Project: EAST CENTRAL HIGH SCHOOL CAFETERIA REMODEL

Owner: TULSA PUBLIC SCHOOLS

Architect: KKT ARCHITECTS, INC.

ADDENDUM NO. 1 11/18/2024

E-101 CAFETERIA – LIGHTING PLAN

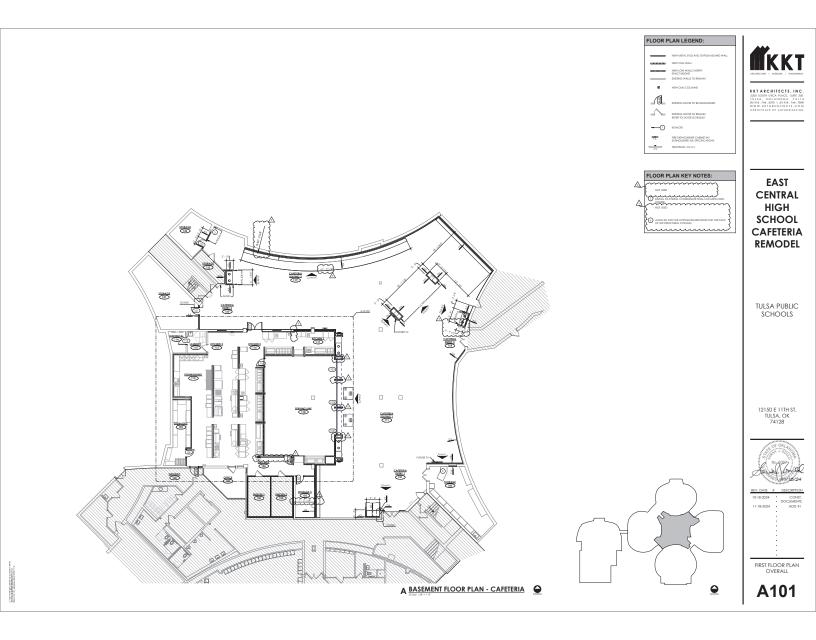
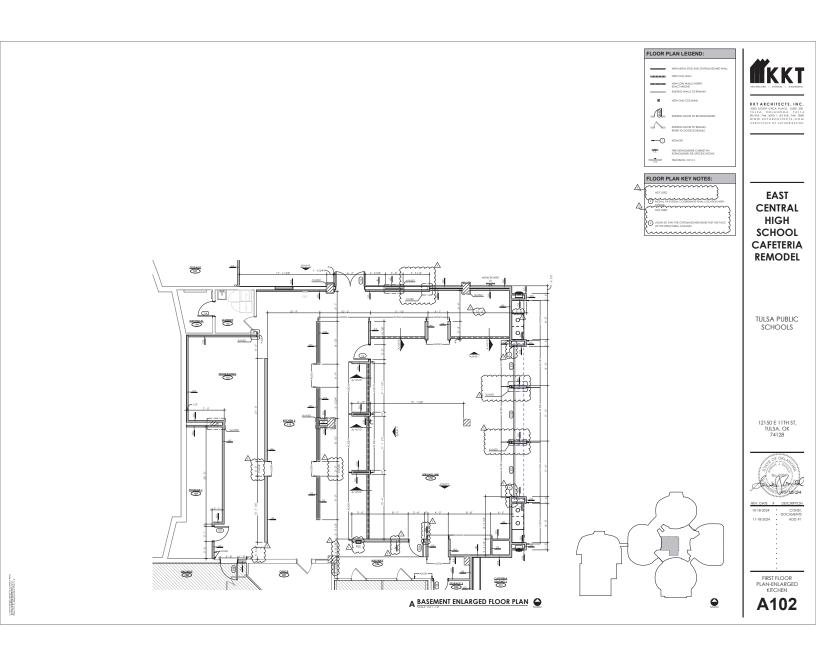
- 1. Added keynote 2 for tape lighting clarification.
- 2. Removed type M fixtures, added keynote to keep existing.
- 3. Added bug-eye fixtures in Elec and Laundry rooms.
- 4. Removed one can light from serving line.

E-201 CAFETERIA – POWER PLAN

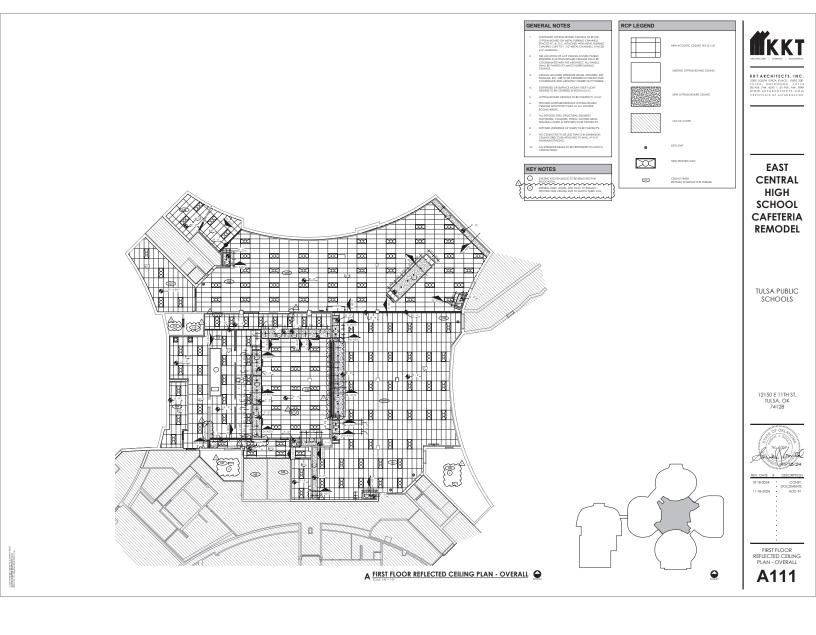
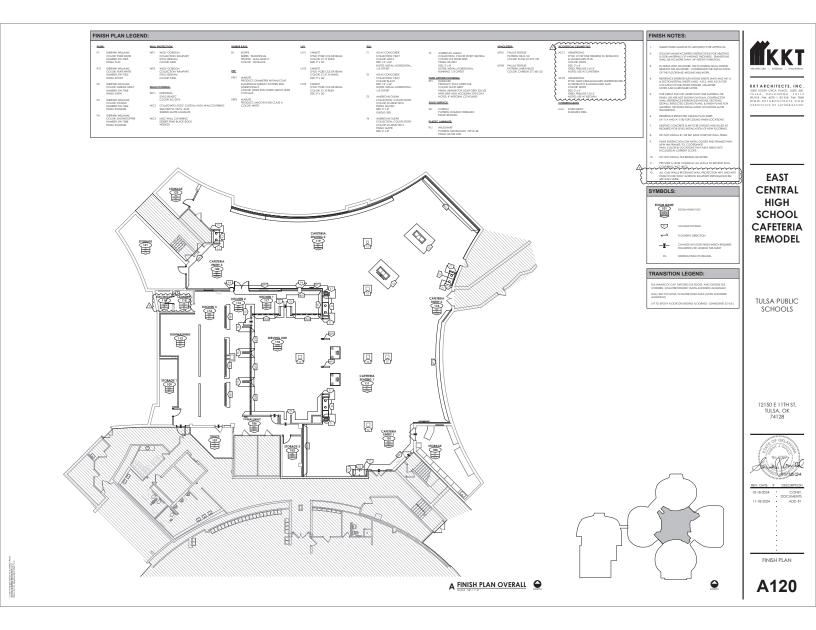
- 1. Moved receptacles to furred out walls and away from furniture.
- 2. Removed power for TV above pickle bar.
- 3. Altered receptacle heights.
- 4. Removed power for Overhead doors.

FINISH FLOOR

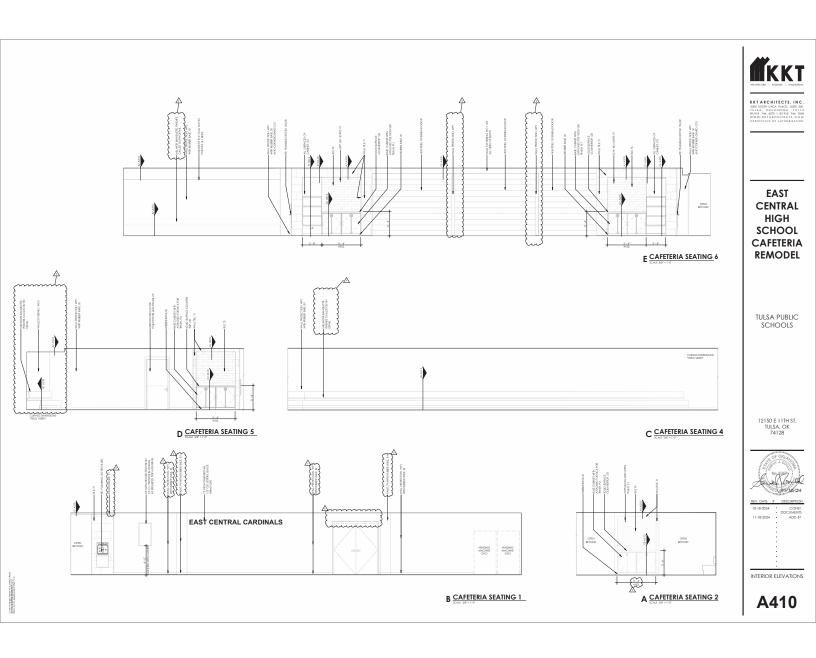
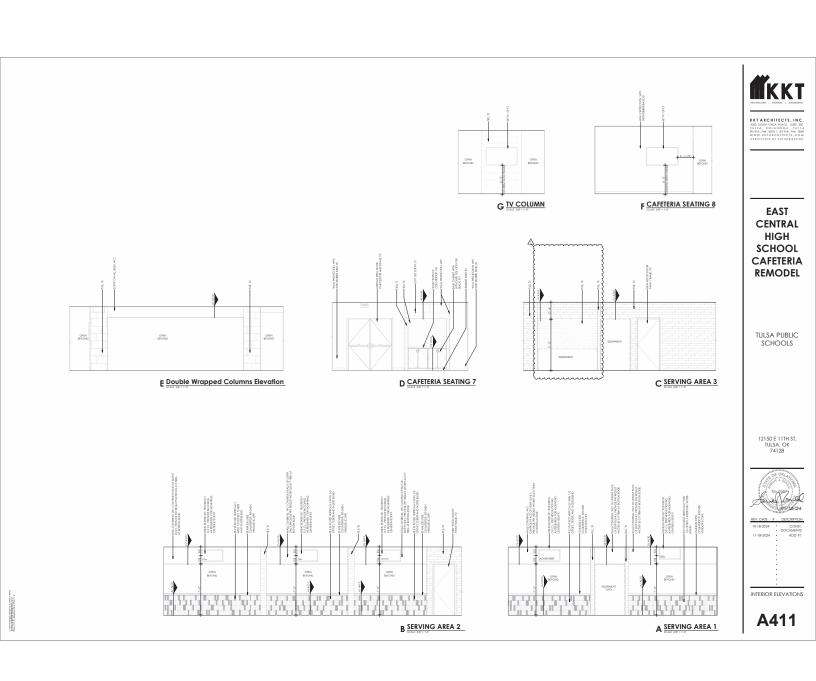
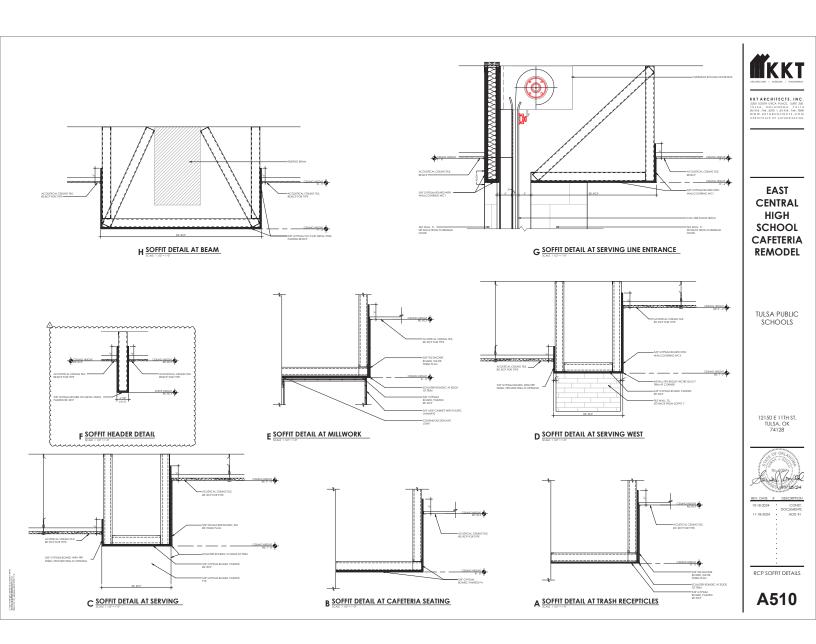
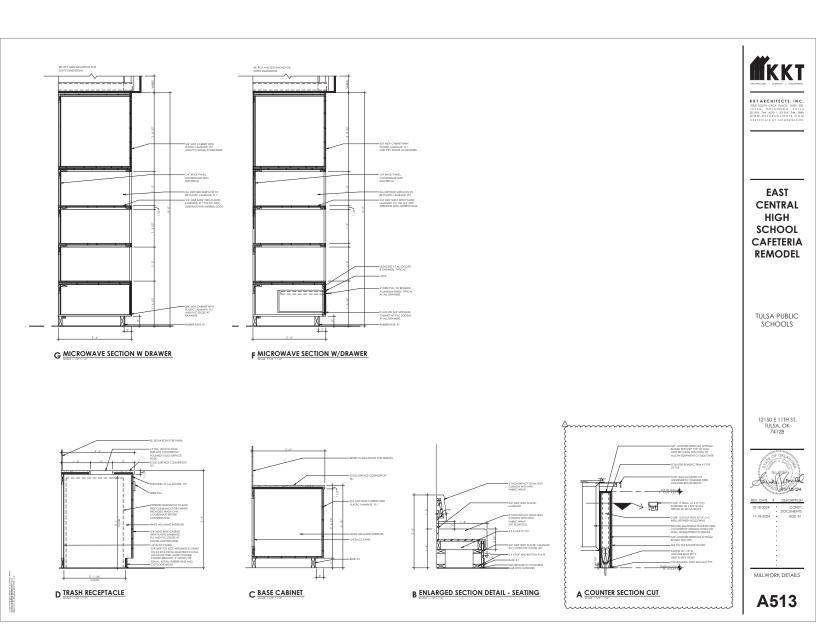
1. Revised finish pattern

FOODSERVICE EQUIP.
PLUMBING CONN.
PLAN
FS301

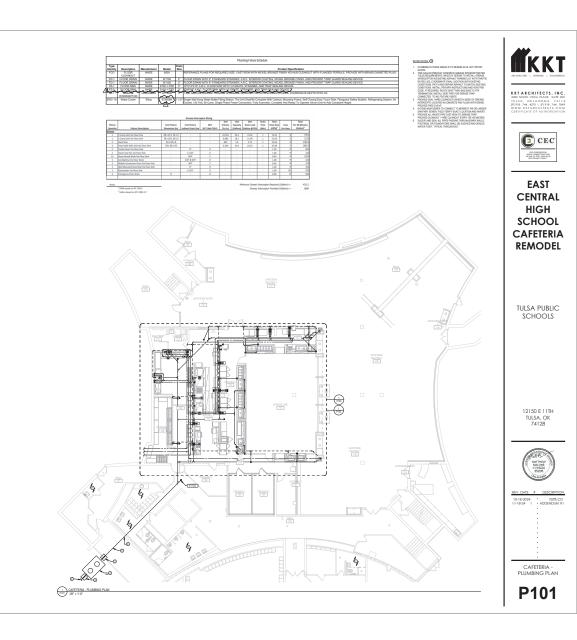
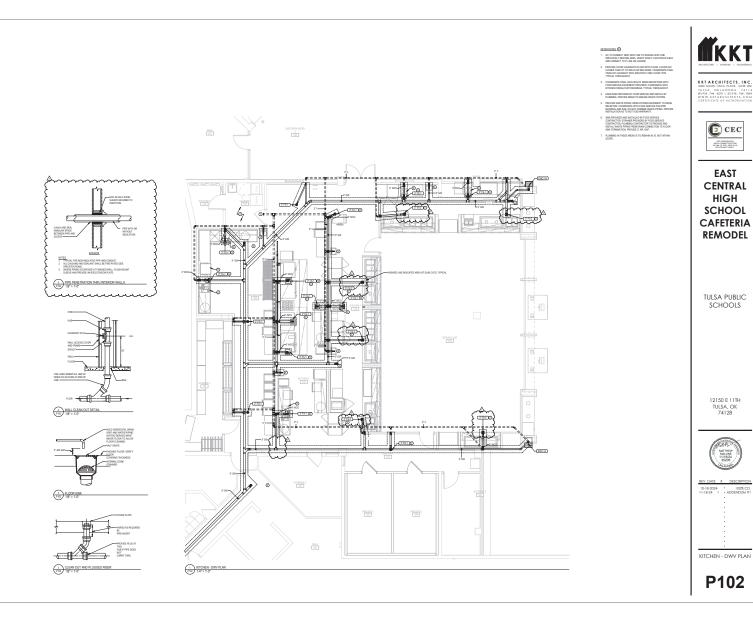
Sheet FS301 - Changed the floor drains at the serving counters to floor sinks.

KITCHEN - DOMESTIC WATER & GAS PLAN

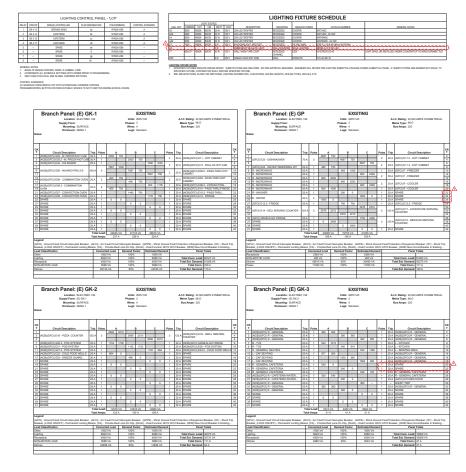
1. Hand sink has been removed from the scope.
